CHAIN OF LAKES DAMS
WAYNE COUNTY, MISSOURI

MISSOURI INVENTORY NOS. 30347
30348
31032

PHASE I INSPECTION REPORT
NATIONAL DAM SAFETY PROGRAM

MAY 1978

PLATE 2

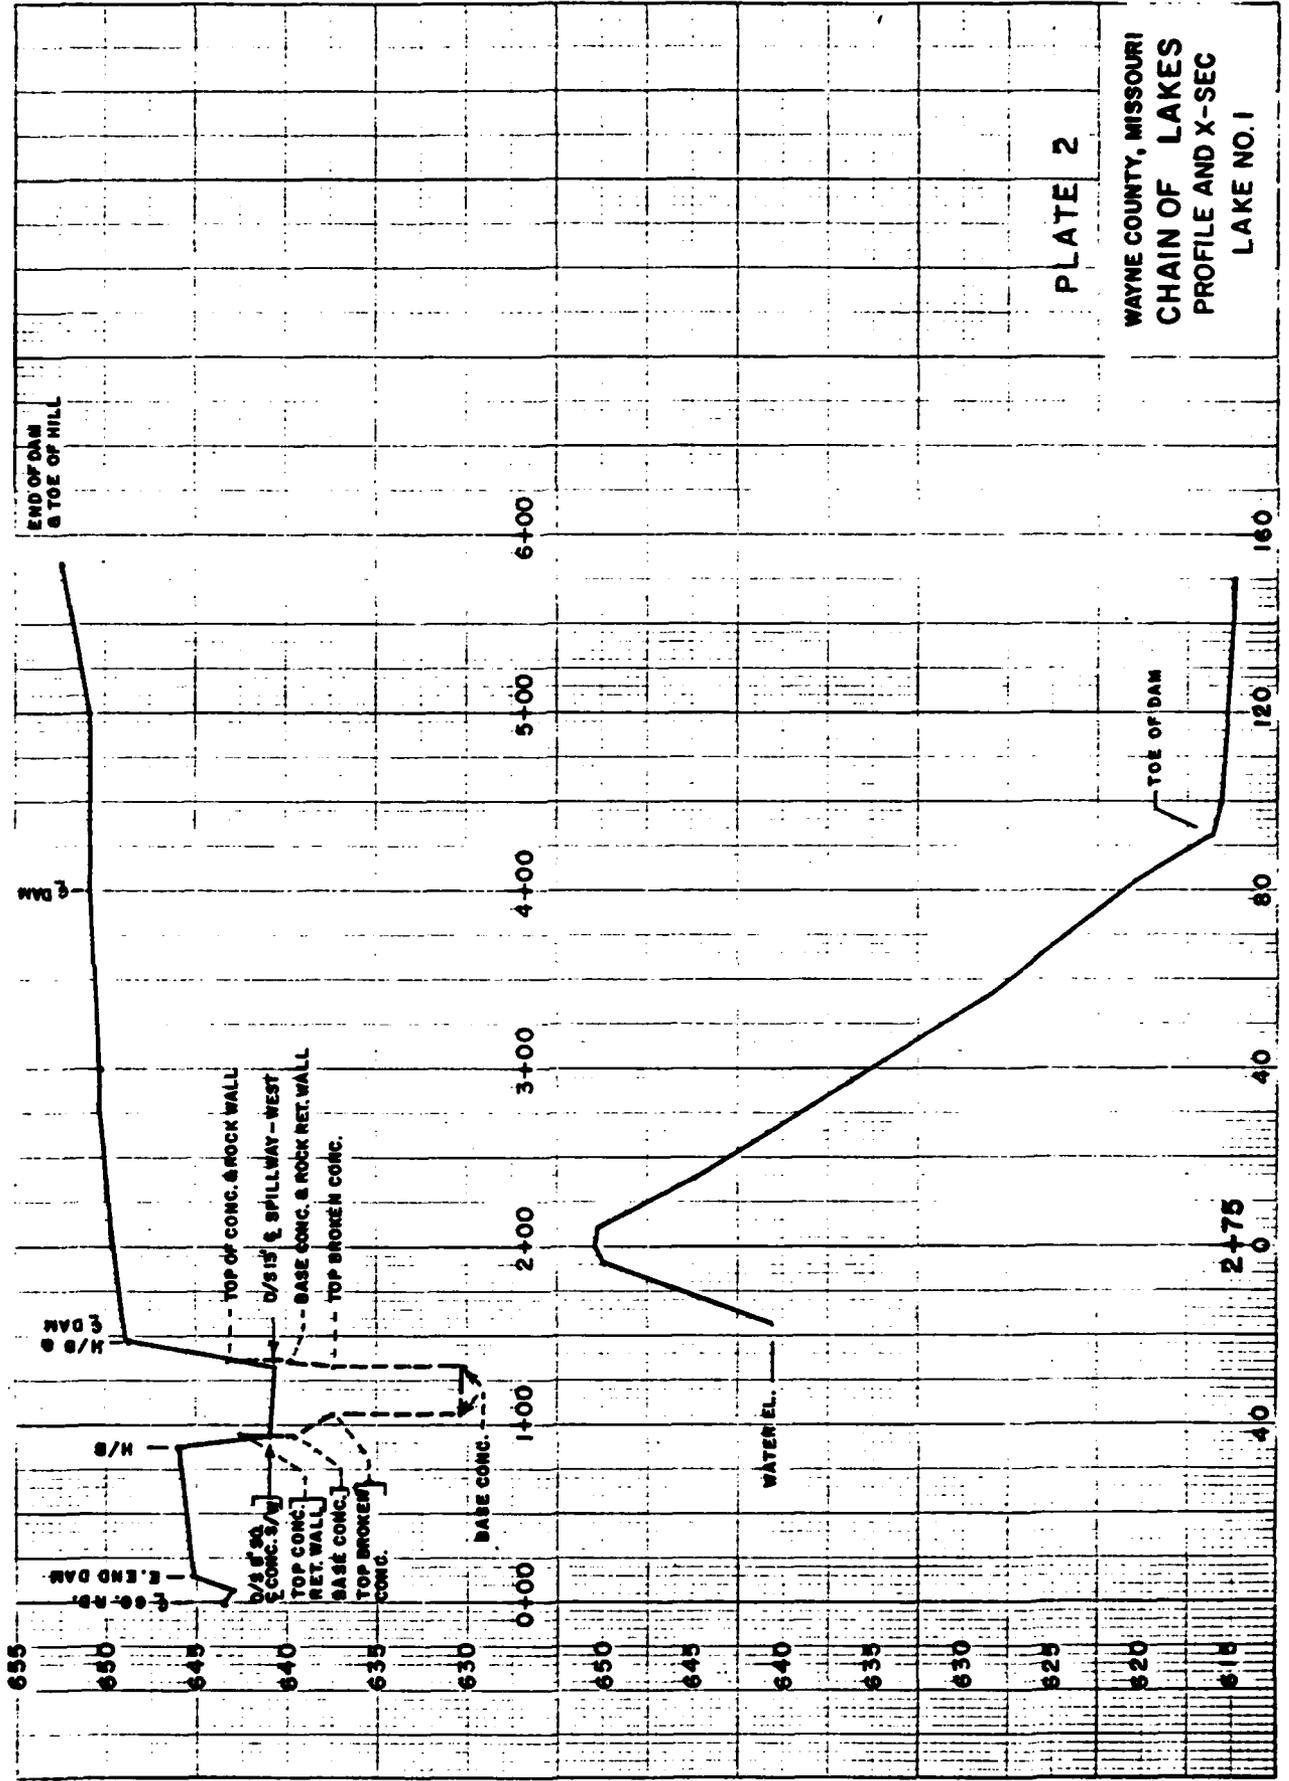
Embankment cross-sections at the maximum height section for each dam are shown on Plates 2 through 4. In a few areas, the embankment slopes are considerably steeper than the section shown. One animal burrow was noted near the crown of dam No. 2. No burrows were noted below pool level at any of the dams but some could be present and masked by vegetation.
